57 17 03 September 20, 2017 **2041749** Supersedes Technical Bulletin V571506 dated December 16, 2016 to include updated production solution and additional repair instructions.

Front or Rear Door Arrester (Door Check Rod/Door Check Strap) Noisy or Defective

Figure 3. Example of door arrester cover with water drain hole for left side of the vehicle ("R top")

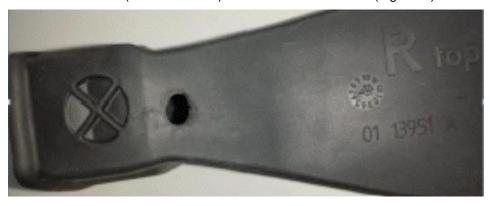
Use a metal drill bit (diameter 8 mm) to drill a water drain hole (Figure 3.) in the door arrester cover as follows.

On the left side of the vehicle the hole must be drilled on the side of the cover where it says "R top" (Figure 4. red ellipse).

On the right side of the vehicle the hole must be drilled on the side of the cover where it says "L top".

Figure 5. Reference point of water drain hole

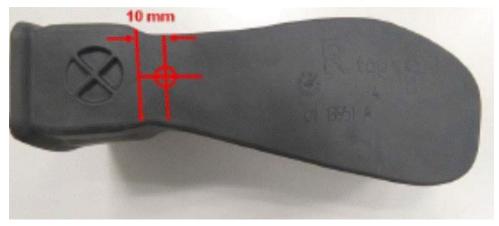
• Drill a water drain hole at a distance of 10 mm in the door arrester cover, measured from the crease in the cover as shown in figure 5.

When the door arrester is installed in the door, the water drain hole must be pointing down towards the bottom of the door.

Figure 6

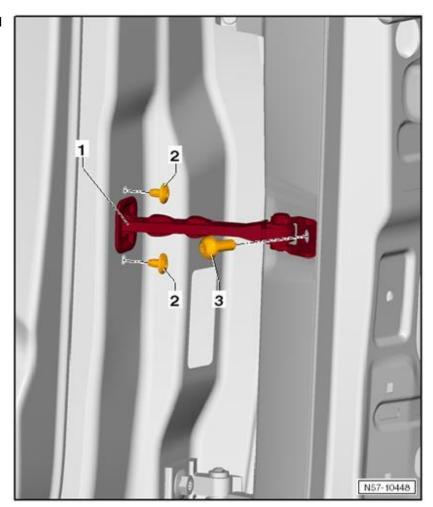
To install the new door arrester, discard the bolts – 2 (figure 6.) from the old door arrester and install the new door arrester using new bolt part number: N 107 732 01 (Figure 7).

The old part number bolts MUST be discarded and the new part number bolts MUST be used for the installation of the new door arrester.
